HERITAGE PRESERVATION BOARD DECEMBER 7, 2020, 6:30 PM 324 EAST PINE STREET, TARPON SPRINGS

Application #20-147 December 7, 2020

CITY OF TARPON SPRINGS Staff Report

SUBJECT: CA #20-147, 150 NORTH SPRING BOULEVARD

Existing windows to be replaced

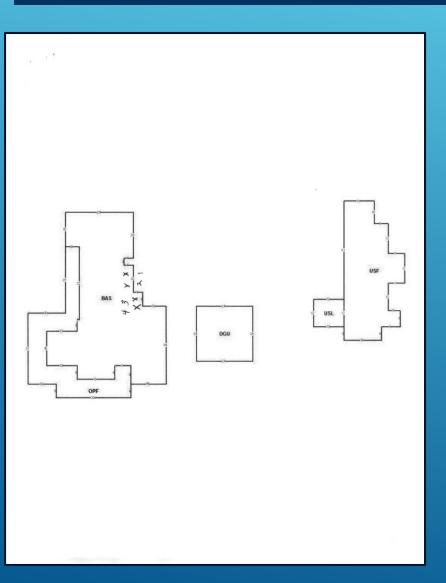
The applicant has proposed the replacement of four wood windows on the east side of the primary structure. The windows to be replaced are on the first floor of the 2-story structure. The applicant is proposing replacement of existing wood windows with vinyl tilt double hung windows. The design will be of a single pane over pane light configuration, matching the existing windows. The FMSF notes double hung 2/2-light wood windows on the principal structure. A site visit to the property revealed that the 2/2-light windows are found on the front of the building. The existing configuration for the windows being replaced is a paired 1 over 1 window. The "pedimented hoods" noted on the FMSF form are present on the affected windows and are not proposed to be disturbed. The applicant proposes size-for-size replacement so that the width and height of the windows as well as the fenestration will remain as currently existing.

ANALYSIS: Window fenestration will not change as a result of the proposed replacements since the proposal is "size for size" in the current configuration. The applicant has not proposed any disturbance of the existing casing, trim, and sills. These features will be required to remain undisturbed except for needed repair and maintenance. The building, after window replacement, is expected to continue to be reflective of the original architectural style. These windows are not visible from the street/sidewalk or other public viewshed.

- 1. Applicant is responsible for obtaining all required permits.
- 2. All existing window surrounds including casing, trim, sills and hood molding shall be retained and shall not be disturbed beyond normal repair and maintenance.

Condition of Windows

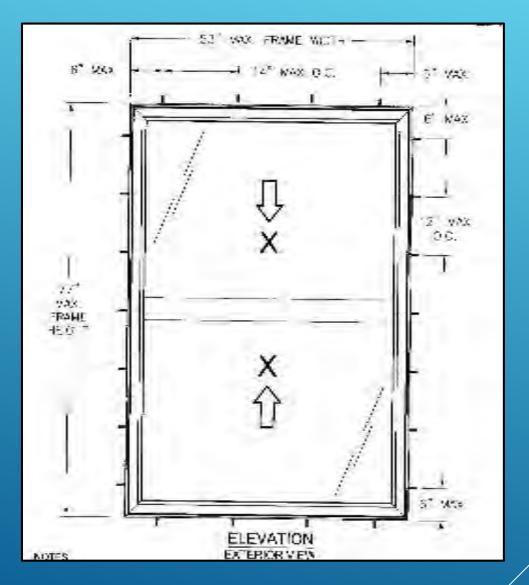
ANALYSIS: The applicant is proposing to replace wood windows with vinyl windows. The applicant has submitted photographic evidence of the condition of the existing windows, showing damage and deterioration of the frames and casing. The applicant has stated that the windows were repaired in the past in 1999 and again in 2010. The history of repairs prior to 1999 (at approximately 110 years of age at that time) is unknown. The windows are now approximated to be at least 120 years old, based on the FMSF form date, and are therefore beginning to approach their end of life. The applicant has stated that the home includes a mix of wood and metal windows. A visit was made to the site on November 30, 2020. The south-facing (front) facade and the east-facing (side) facade were observed

The windows to be replaced have wood casing, trim and sills bordering their exteriors including the pediment style hood molding. The photographic evidence submitted by the applicant appears to show some damage to the casing. However, the casing and other surrounding features are apparently being retained, and this is recommended as a condition of approval. The design of the proposed window replacements are consistent with the character of the building's original architectural style and do not detract from it.

The HPB should evaluate the evidence submitted by the applicant regarding the window deterioration and determine whether the replacement is required and whether a wood replacement product was fully considered. It does appear that there is substantial deterioration present, and, the windows are at least 120 years old. The applicant dates the principal structure (and therefore the windows) at 135 years old.
